# Wollongong Local Planning Panel Assessment Report | 18 July 2023

<b>WLPP No.</b>	Item No. 4
<b>DA No.</b>	DA-2022/1278
<b>Proposal</b>	Residential - demolition of existing buildings, removal of vegetation and construction of a mixed-use development
<b>Property</b>	29 -31 Denison Street WOLLONGONG
<b>Applicant</b>	Design Workshop Australia
<b>Responsible Team</b>	Development Assessment and Certification - City Centre Major Development Team (NL)
<b>Development cost</b>	\$12,823,354
<b>Lodgement date</b>	24 November 2022
<b>Prior WLPP meeting</b>	N/A

## ASSESSMENT REPORT AND RECOMMENDATION

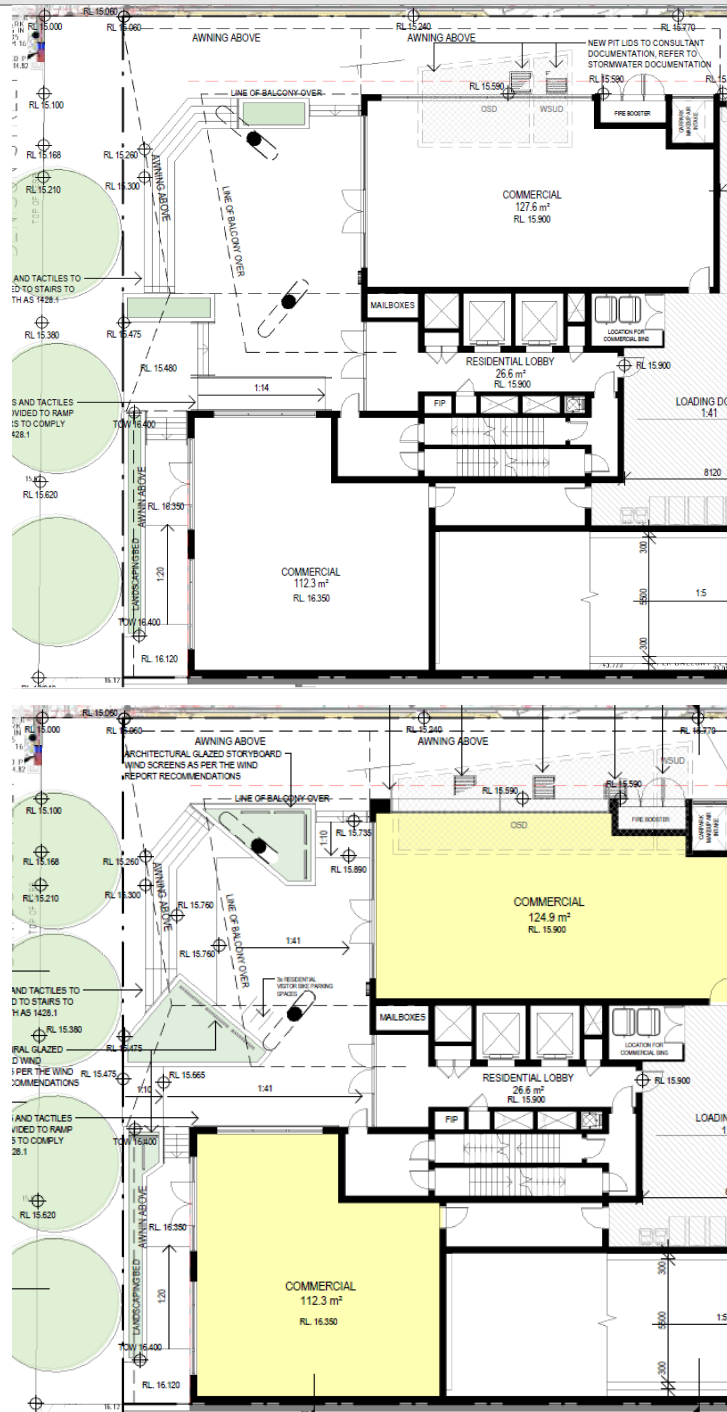
The southern façade requires greater articulation and visual interest.

Recommendation for a more prominent pergola/roof element that related to both the uses at the COS and the visual form of the street level entry canopy may be incorporated at roof level.

The roof form has been altered to mirror the angled awning structure over the ground floor commercial tenancy.

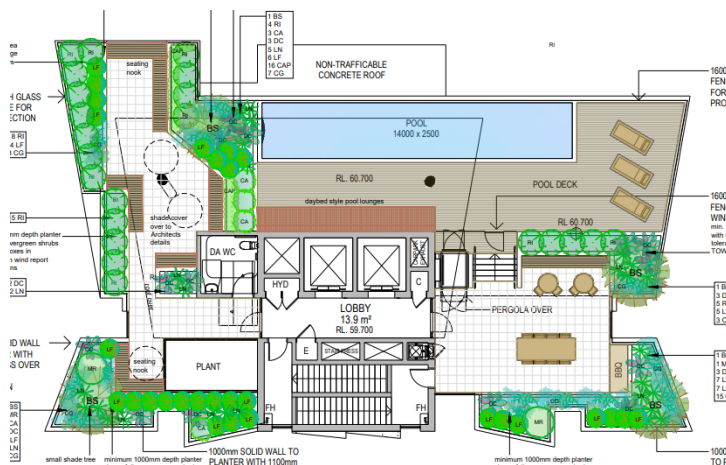
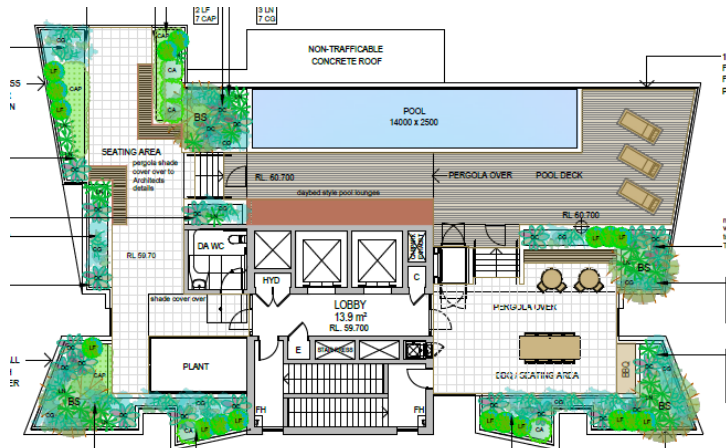
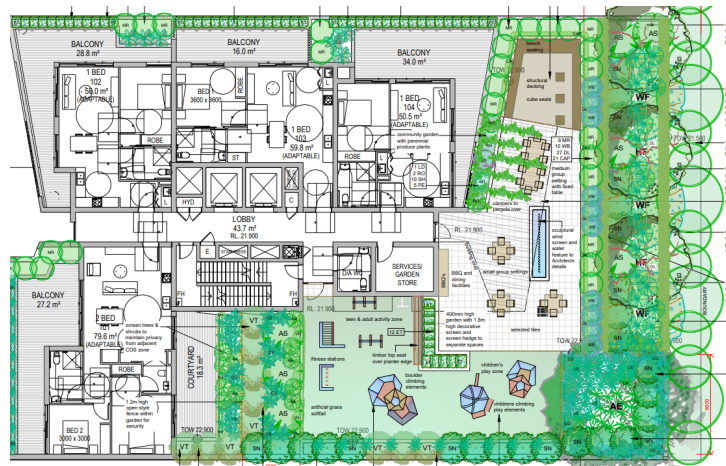
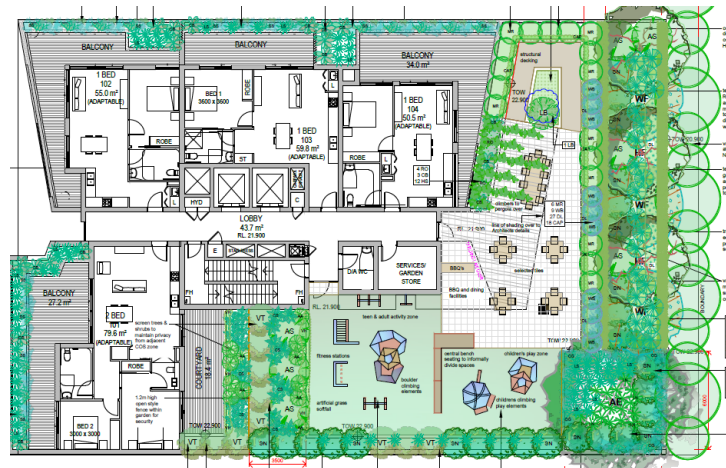
Question the proposed tree planting to Denison Street	Council's Landscape Officer has reviewed the proposal in regard to the proposed tree plantings and consistency with Council's public domain policy and has advised of conditions of consent.
The design and alignment of landscape elements within the entry landscape should complement the aesthetic of the canopy feature over. Instead of squared off planters and alignments, perhaps this area could reflect the angular design of the folded canopy.	See images above
